**FINDINGS AND RECOMMENDATION
OFFICE OF PLANNING AND ZONING
ANNE ARUNDEL COUNTY, MARYLAND**

CASE NUMBER: 2025-0150-V

REQUEST

The applicants are requesting a variance to allow the partial conversion of an accessory structure (detached garage) into a two-story accessory dwelling unit and a two-car garage with less setbacks than required and located in the front yard of a nonwaterfront lot at 10 6th Avenue in Brooklyn.

PROPERTY SURVEY
LOCATION DRAWING
LOTS 20, 21 SECTION 1E
BROOKLYN PARK
JOHN K. CULVER SUB N° 1
PLAT BOOK 14 PAGE 21
SCALE 1" = 30' SEPT 02, 1999

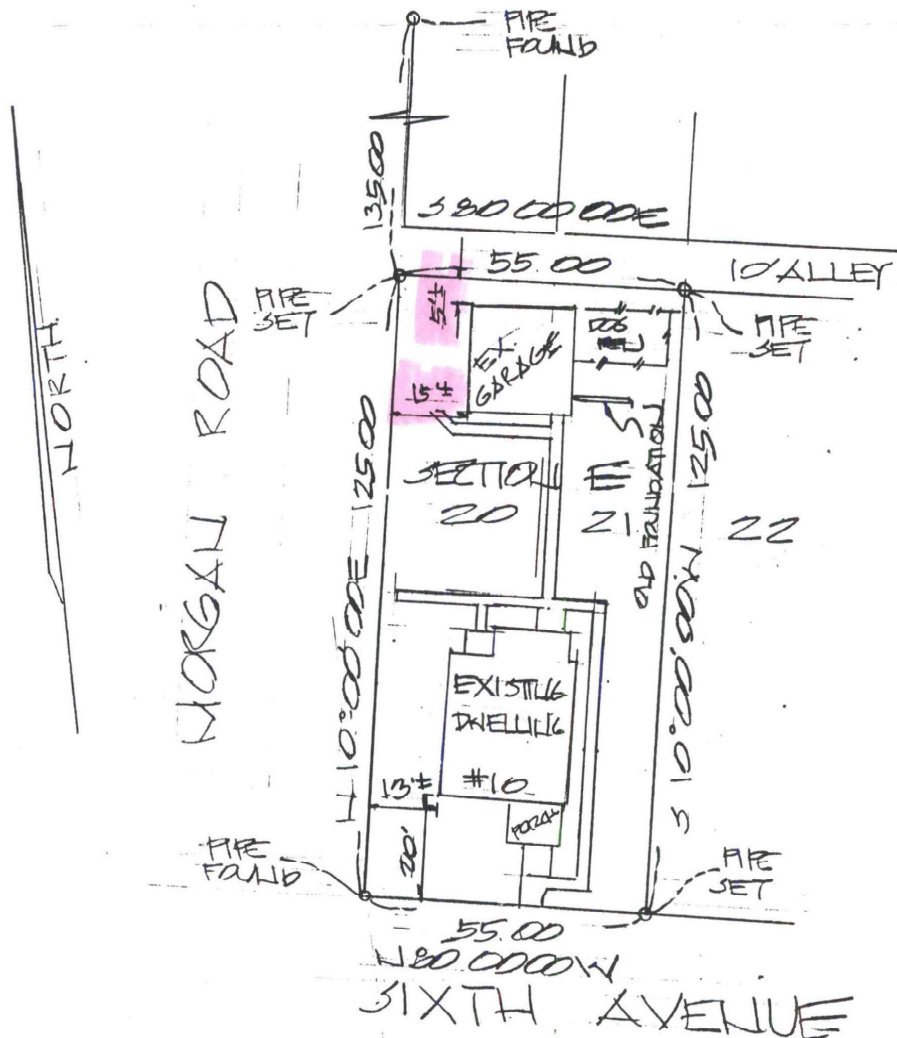
The subject lot is smaller in area and width than a current R5 lot. The existing 20'x20' garage is located five (5) feet from the alley/rear lot line and 15' from the side street. The requested 28'x36' garage seems excessive. A 20'x32' garage can be placed using the current garage's location in regard to the alley/rear. The side street and east side setbacks can be met. A variance of five (5) feet to the alley/rear setback would be required to extend the existing footprint to the east.

Based on the above, this Office cannot support the requested variances but would recommend approval of a 20'x32' garage with a variance of five (5) feet to the alley/rear setback.
